DEVELOPMENT REVIEW COMMITTEE (DRC) COMMENT REPORT

PROJECT NAME: 530 Birch

CASE NUMBER: R18065

REQUEST: Site Plan Level IV Review: 21 Multifamily Residential Units

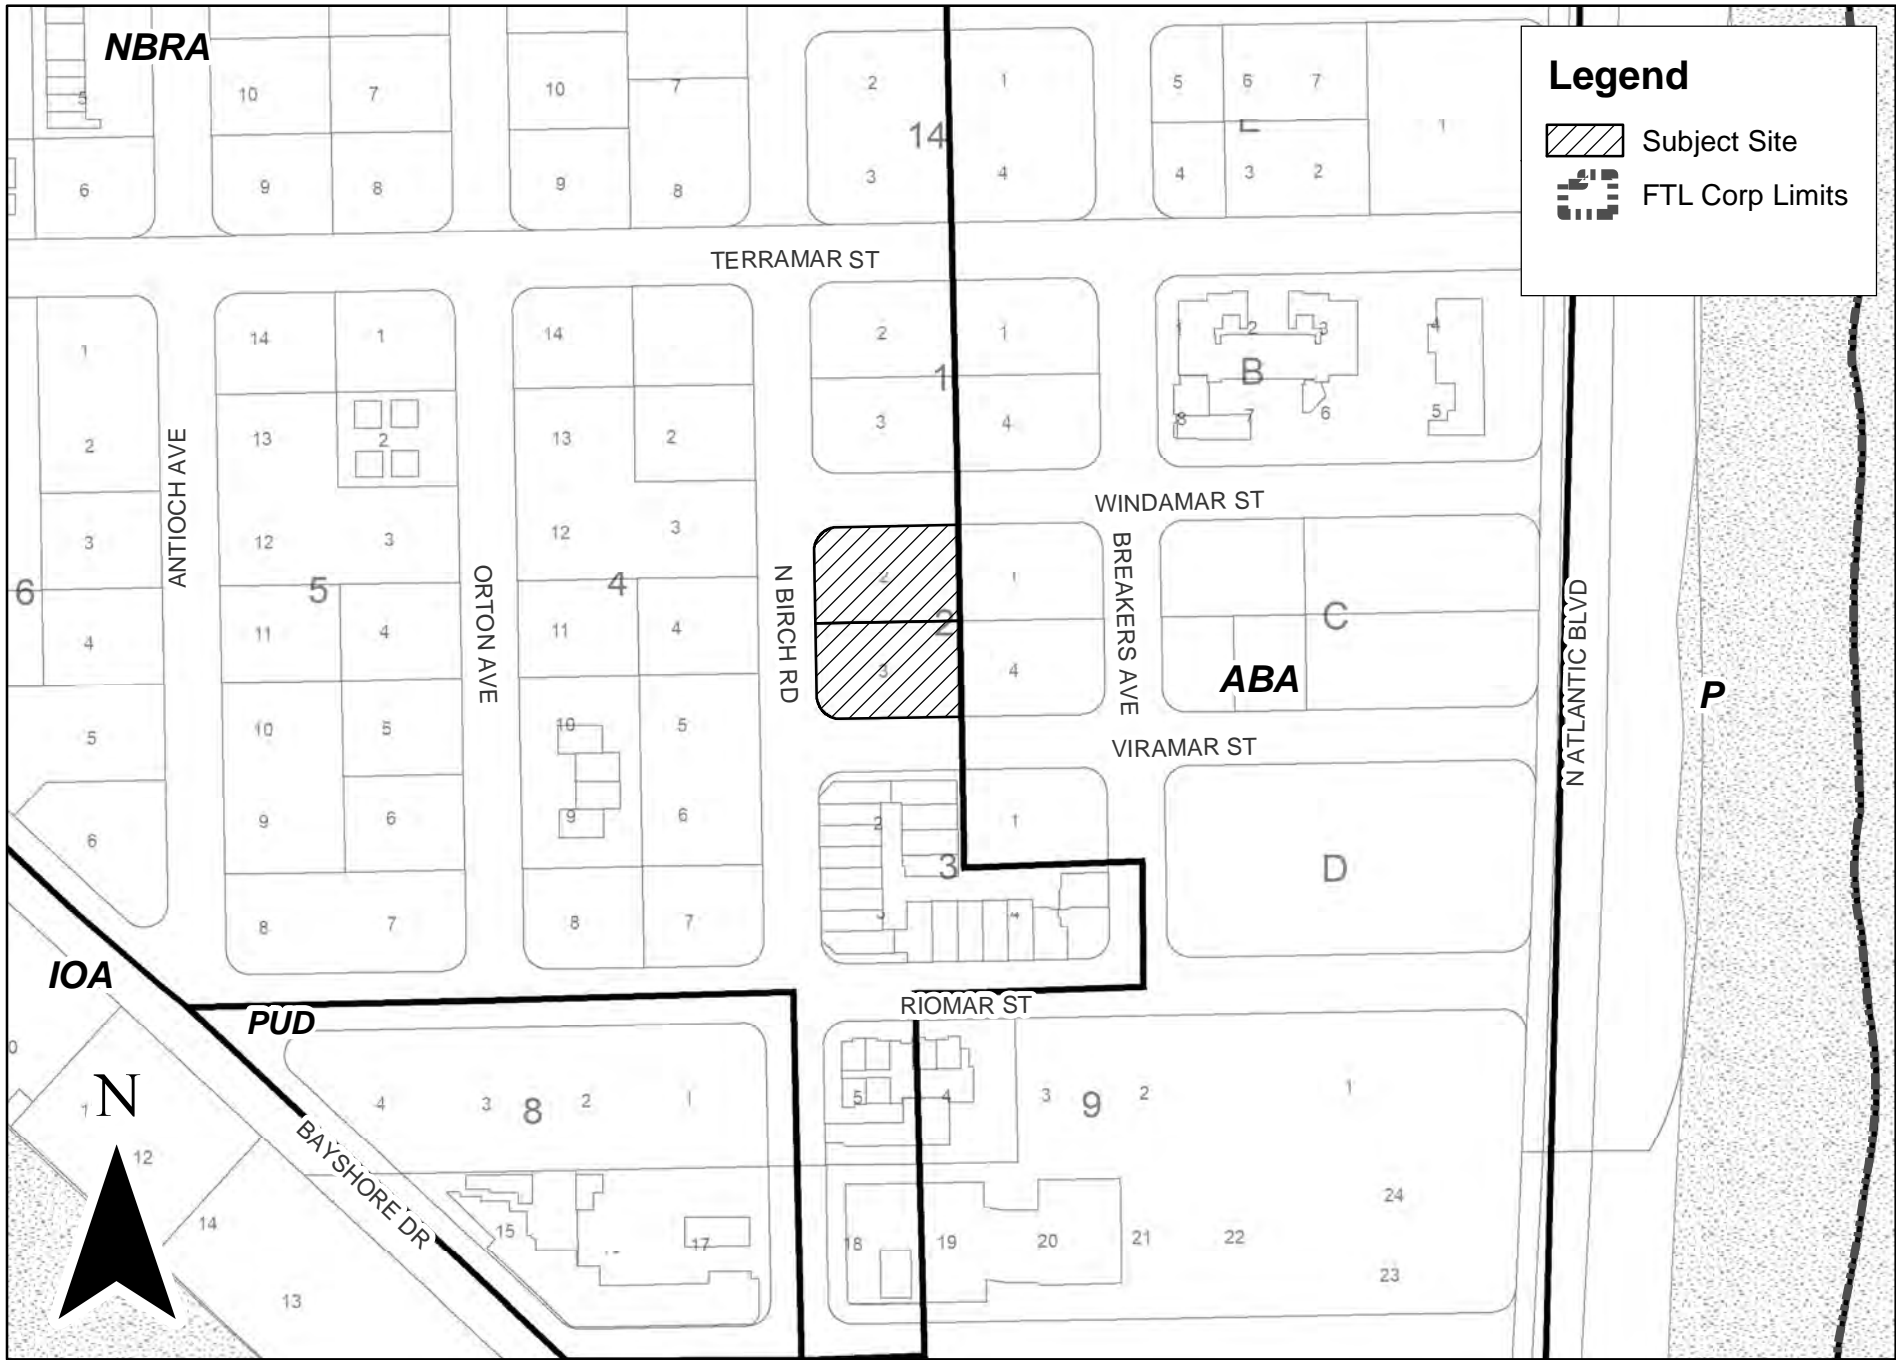
The City owns and maintains stormwater infrastructure adjacent to the proposed development as shown with green line work in the map provided at the end of this report. **Civil plans shall show the City's stormwater inlet ID #s as identified in the map provided at the end of this report.** The following comments pertain to possible impacts of the proposed development and/or construction activities to the existing condition of the City's stormwater assets. The applicant shall provide an itemized response letter addressing the following comments:
